INSTRUCTION TO SERVICE

ITS60844		19-Oct-2023
SECTION:	219-Engine and Transmission	
WRITTEN BY:	Mike Pearson	
SUBJECT:	Retorque Transmission Yoke as per Allison Document SIL 20-WT-23	
ISSUE:	<i>This is to inform you that your vehicle may be non-compliant with the requirements of the Motor Vehicle Safety Regulations and that the non-compliance could affect the safety of a person.</i> Allison Transmission has observed a potential concern that affects the output shaft yoke/flange retaining bolt	
SUMMARY:	As a Customer Satisfaction Initiative, Allison will support increasing the output shaft yoke/flange retaining bolt torque specification for B3400 R xFE™ and B400 R Series transmissions.

SIL 20-WT-23
October 16, 2023
Product Code(s): 65
Page 1 of 3

SUBJECT: Output Shaft Yoke/Flange Retaining Bolt Torque Specification Increase

Figure 2.

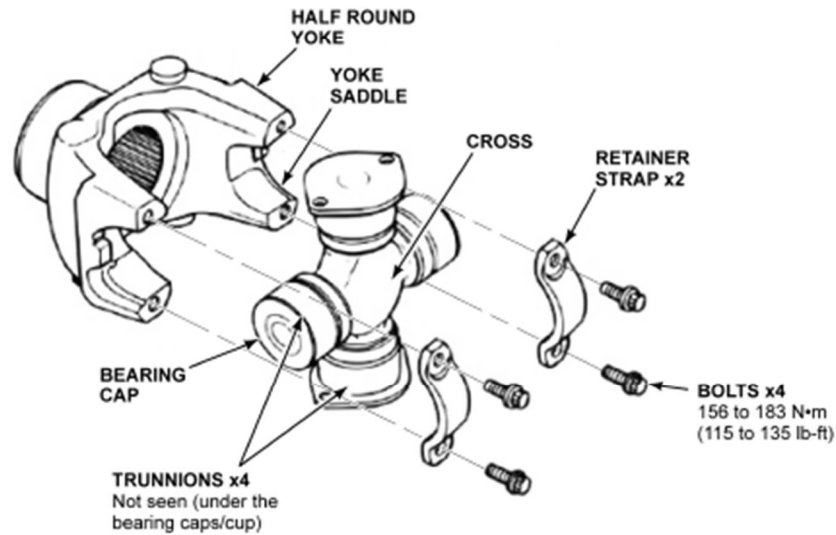
7. Reinstall driveline and secure u-joint to transmission output yoke with new straps and bolts from hardware kit.
- Follow manufacturer's torque procedure and specifications. Refer to [Figure 2](#).
 - Prior to lowering bus from lift, mark transmission nameplate with paint pen to indicate output shaft yoke/flange retaining bolt torque has been verified.
